**SECTION 16 PLANNING APPLICATION NO. A/YL-NSW/357**

**Further Information Submission**

Section 16 Planning Application No. A/YL-NSW/357

**Response to Departmental Comments Table**

Drainage Proposal

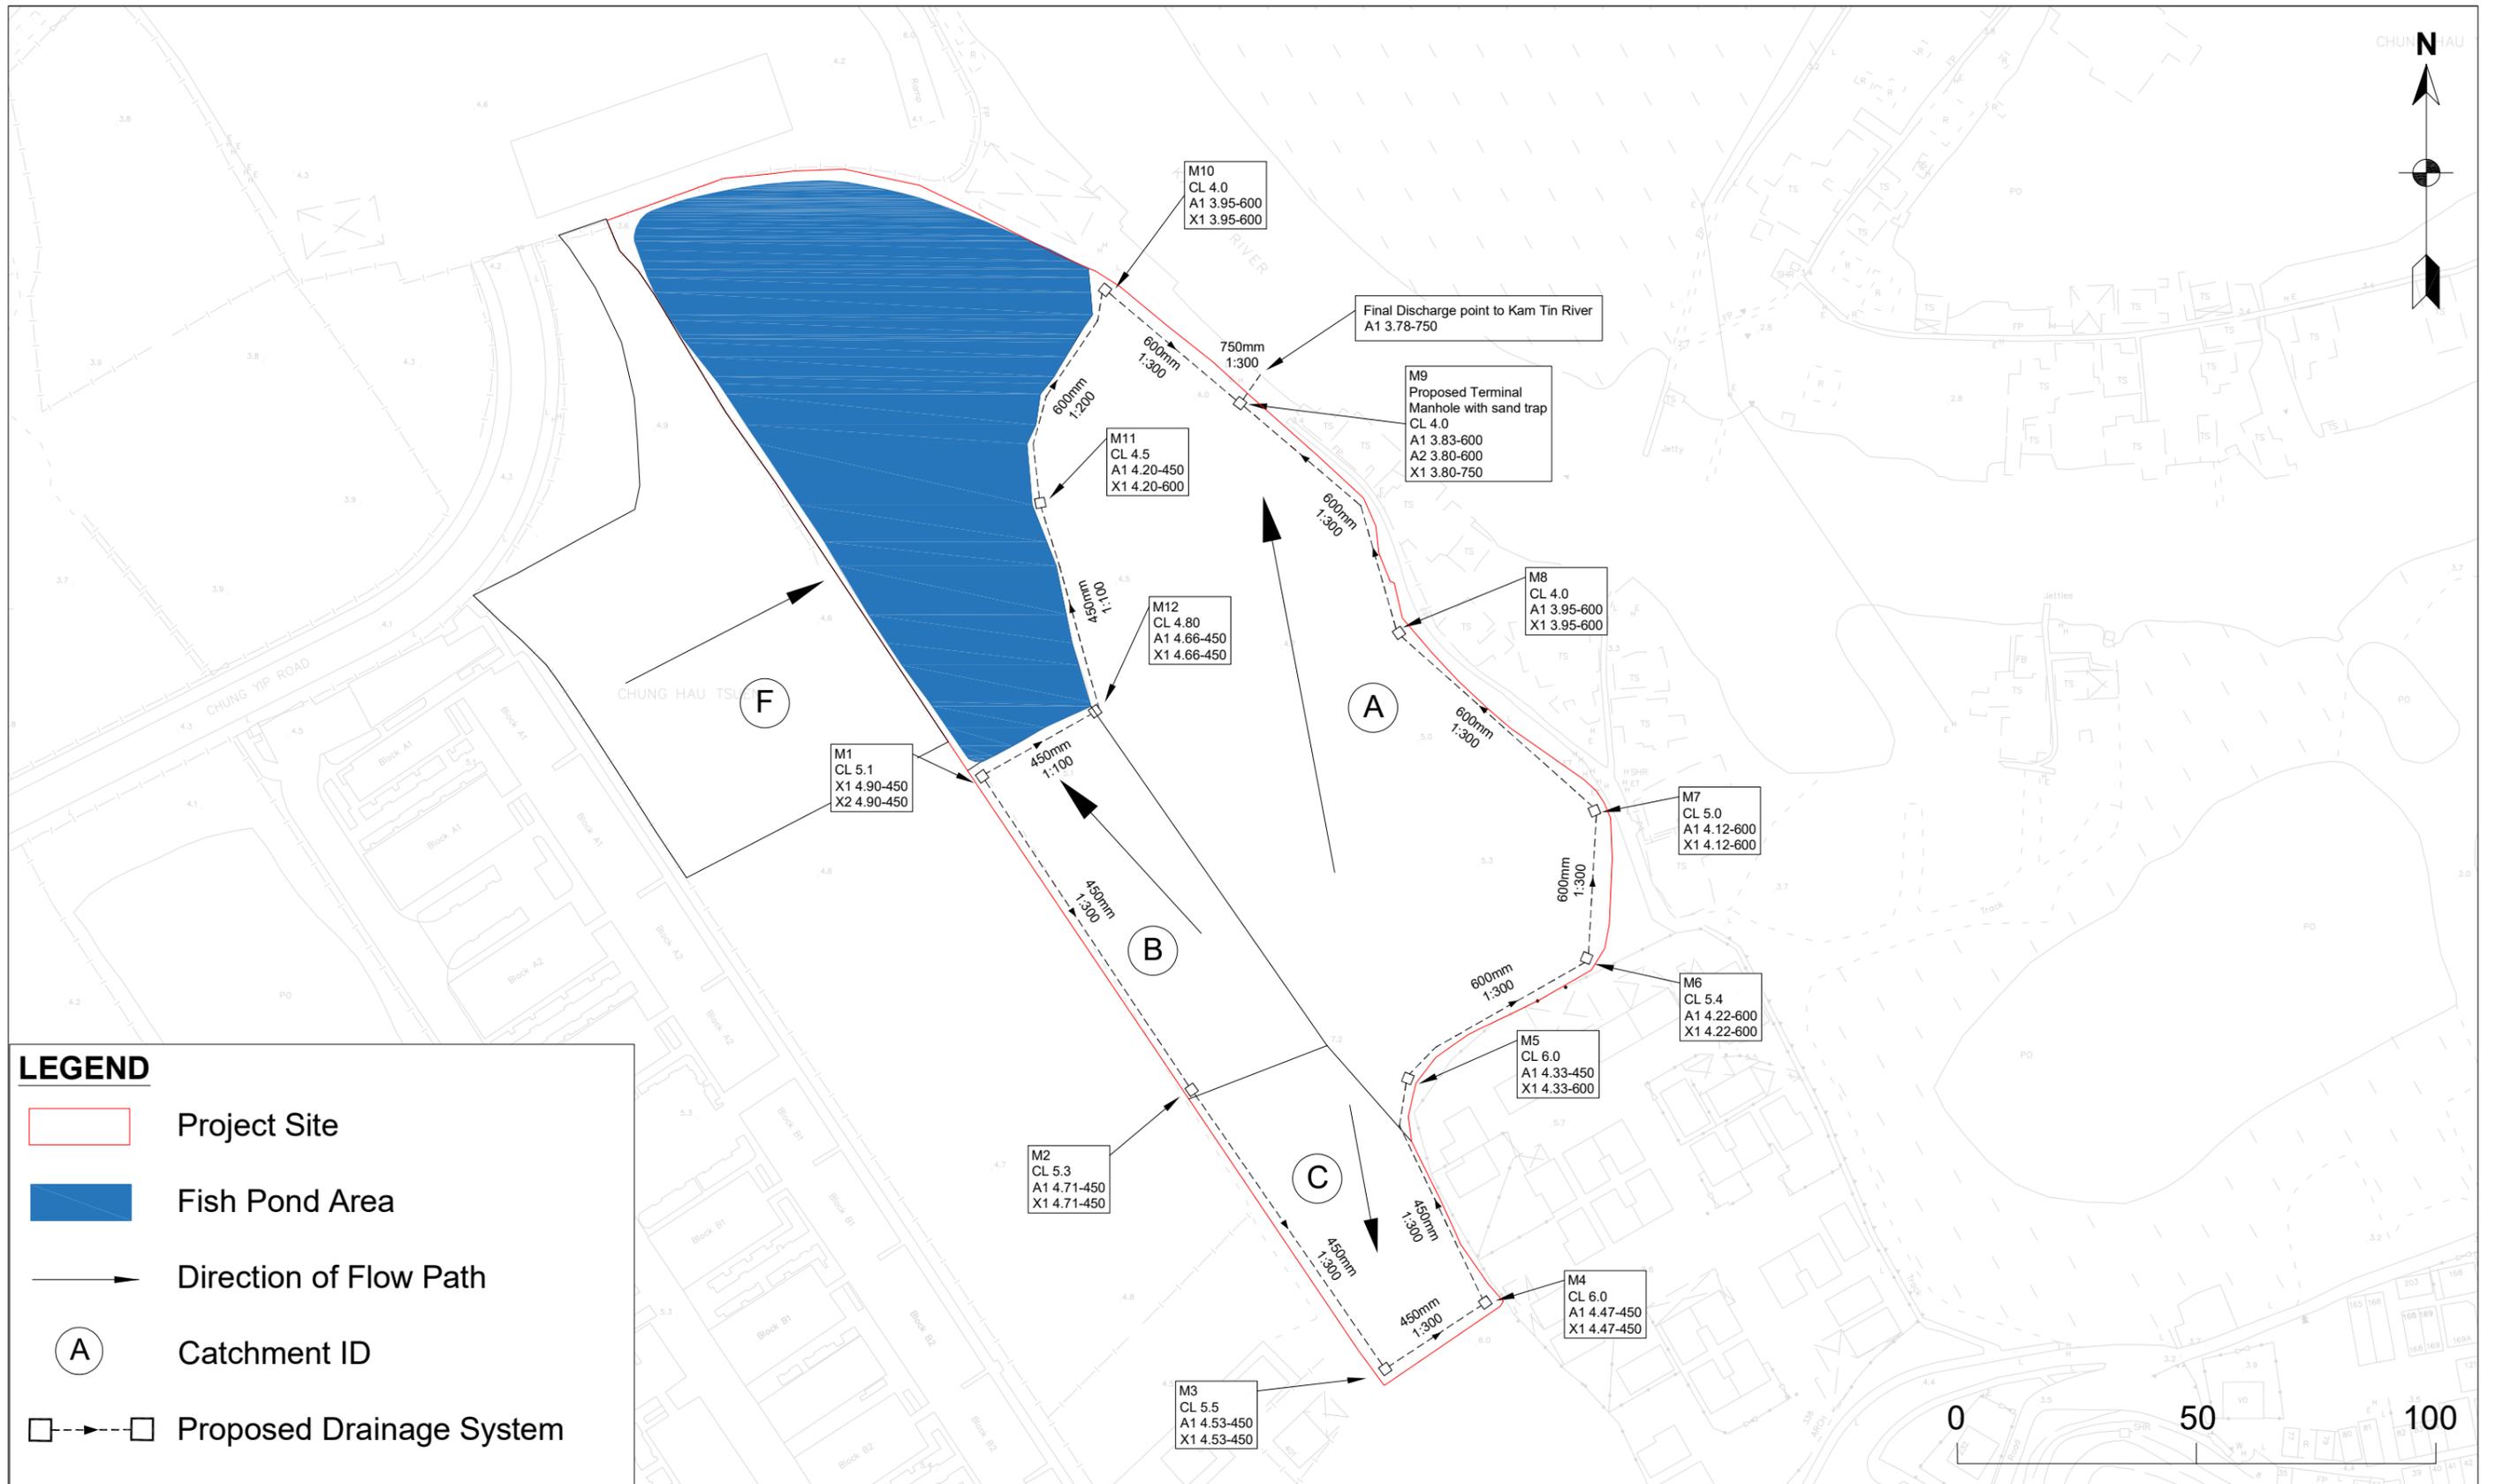
1.	The applicant should review size of the proposed drainage facilities at the downstream of the proposed sand trap M10. Size of the proposed drainage facilities at the downstream should be equal to / larger than that at the upstream;	The size of the proposed circular pipe from M10 (now updated as M9) to Kam Tin River is 750mm. Please refer to <b>Figure 3.2</b> of the <b>Drainage Impact Assessment (DIA)</b> .

6.	Peripheral surface channels shall be provided to collect the surface runoff accrued on the application site and to intercept	Peripheral surface channels are provided on the Site. Please refer to <b>Figure 3.2</b> of the <b>DIA</b> .

8.	The applicant should ensure that all runoff currently directed towards the pond would be intercepted and redirected to the proposed drainage system;	Peripheral surface channels are provided on the Site. Please refer to <b>Figure 3.2</b> of the <b>DIA</b> .

Cross Section - Section A

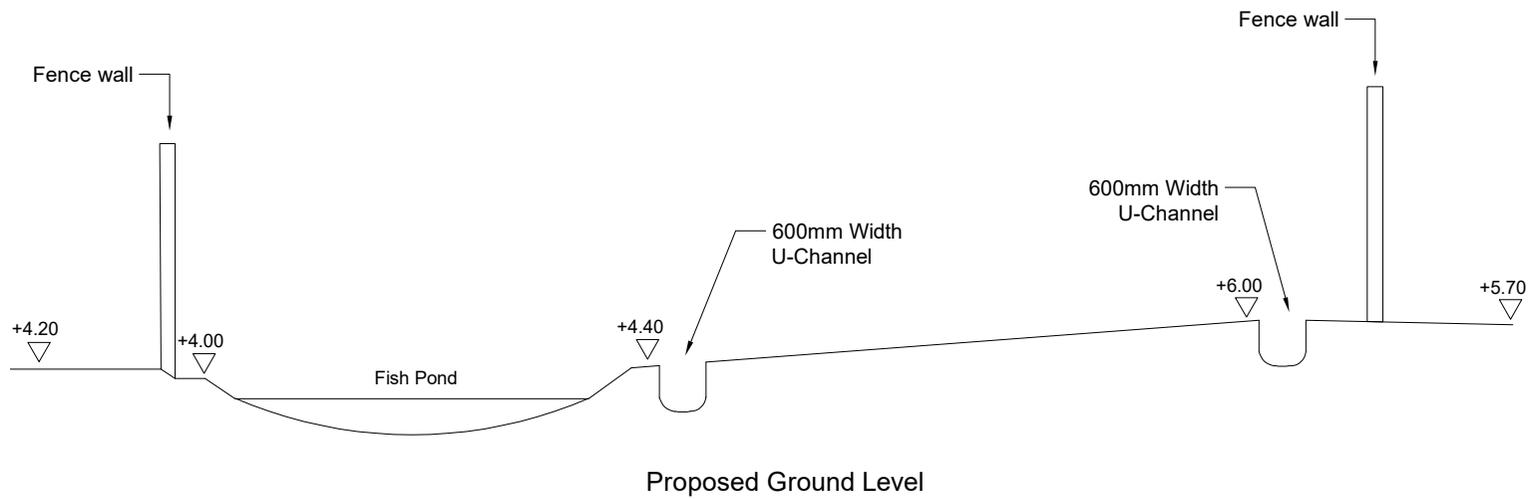
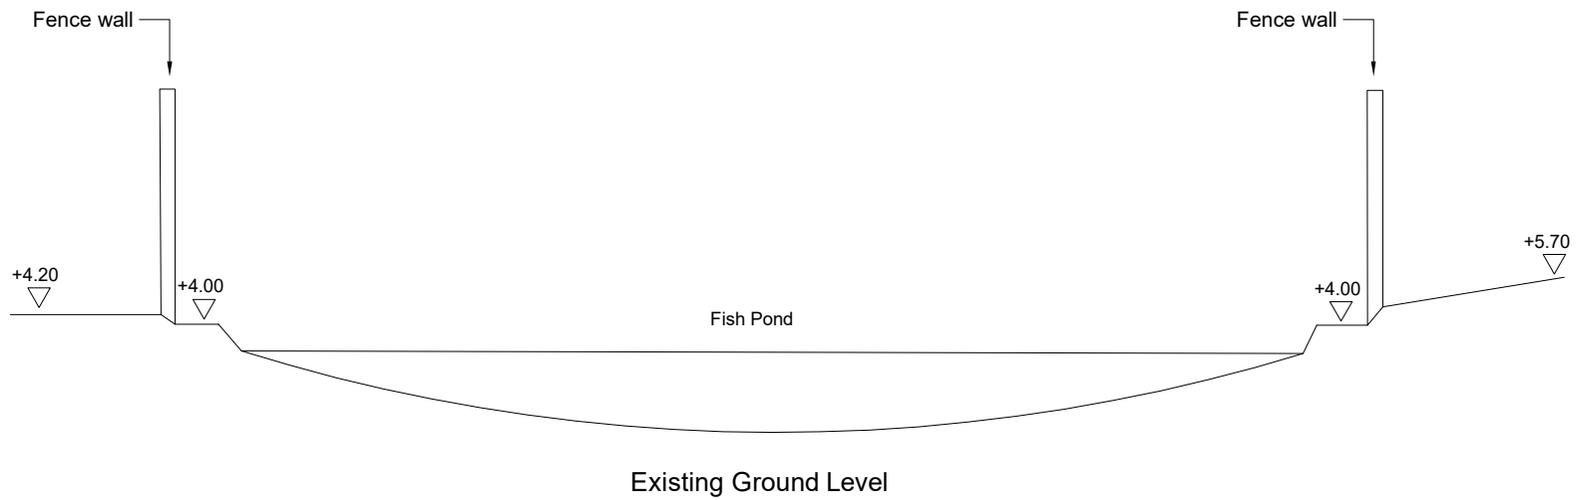
2.	Figures 3.2 & 3.3: The applicant should clarify discrepancies of sizes of the proposed drainage facilities shown on the submitted plans. The applicant should update the hydraulic calculation in Appendix C if necessary;	The figures have been updated accordingly. Please refer to <b>Figures 3.2 and 3.3</b> of the <b>DIA</b> .

5.	Cross Sections showing the proposed drainage facilities and existing and proposed ground levels of the captioned site with respect to the adjacent areas should be given;	The figures have been updated accordingly with the ground levels with respect to the adjacent areas. Please refer to <b>Figures 3.3A to 3.3D</b> of the <b>DIA</b> .
